Subject: MHI's Revised Response to US-APWR DCD RAI No. 427-2909 REVISION 1 (SRP 12.02)

Revised Response to Request for Additional Information
No. 427-2909 REVISION 1

RAI NO.: NO. 427-2909 REVISION 1
SRP SECTION: 12.02 – Radiation Sources
APPLICATION SECTION: 12.2
DATE OF RAI ISSUE: 7/30/2009

QUESTION NO.: 12.02-19

Figure 1 Treatment of the Cubicle in the Airborne Activity Calculation (example)

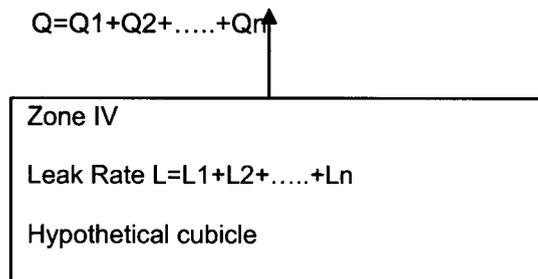
- I) A number of "Radiation Zones" are listed (III to VI). Since there are other zones depicted in Figures 12.1-1 sheets 1-34 "Radiation Zones for Normal Operation/Shutdown", and the RB and AB have piping and equipment areas containing these missing zones, it is not clear how the listed zones were derived and where they are defined.

As depicted in Figure 1 below, this calculation models all cubicles assigned to the same radiation zone category as a single hypothetical cubicle. Airborne activity is calculated using Eq. 3 (see the answer to 1a above) and does not depend on cubicle volume. Therefore, this

treatment considers all of the cubicles in the radiological controlled area (RCA). Radiation Zone I is not RCA. Radiation Zone II is the RCA, but the equipment that can potentially leak radioactive liquid is not located in this Zone. The equipment that could potentially leak radioactive liquid (e.g. pumps) is installed in Zones III and higher. Therefore, MHI revised DCD Table 12.2-60 and Table 12.2-61 with a note.

Figure A-2: Comparison between US-APWR estimation conditions and realistic conditions

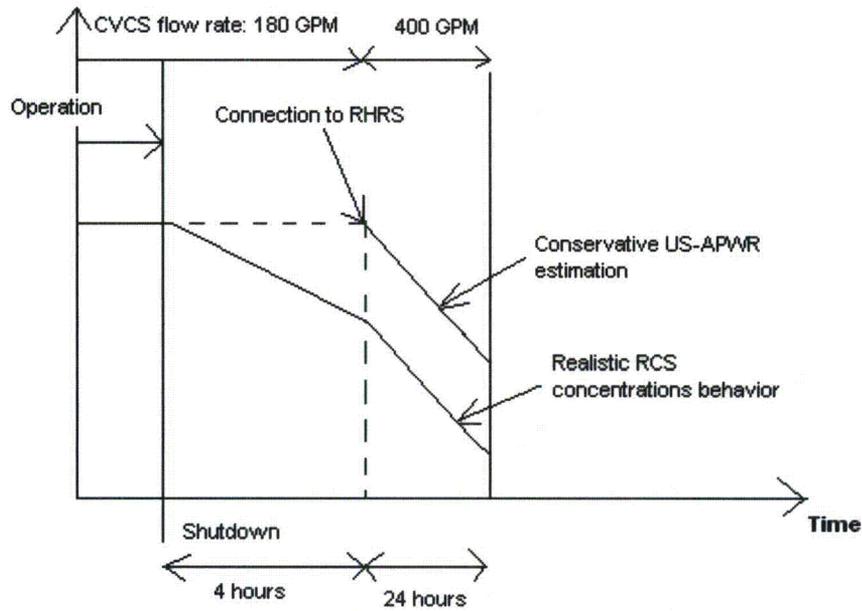
3. The values in Table 12.2-72 do not appear to be consistent with the values in Table 12.2-52 "RHR System Activity – 4 Hours After Shutdown", even when the Table 12.2-52 values are corrected for clean up to the EPRI Primary Water Chemistry Guidelines, and then diluted with distilled water (not RWSAT) to fill the Cavity.

Figure A-2 describes the assumptions used in the estimation of RCS concentrations for the US-APWR in comparison to the actual conditions expected.

As shown in Figure A-2, the US-APWR estimation conservatively assumes that the concentration of radionuclides in the RCS remains constant during the period between the beginning of shutdown and the start of the RHRS (i.e., no decay and no CVCS purification is credited prior to RHRS initiation). Both decay and purification (400 gpm) are credited for a 24 hour period between the connection of the RCS to the RHRS and the end of shutdown when operators can begin refueling operations. However, practical considerations of refueling outage risk management will prevent fuel movement until well after 24 hours, resulting in additional purification and decay beyond what is currently conservatively modeled in the US-APWR airborne activity concentration evaluation.
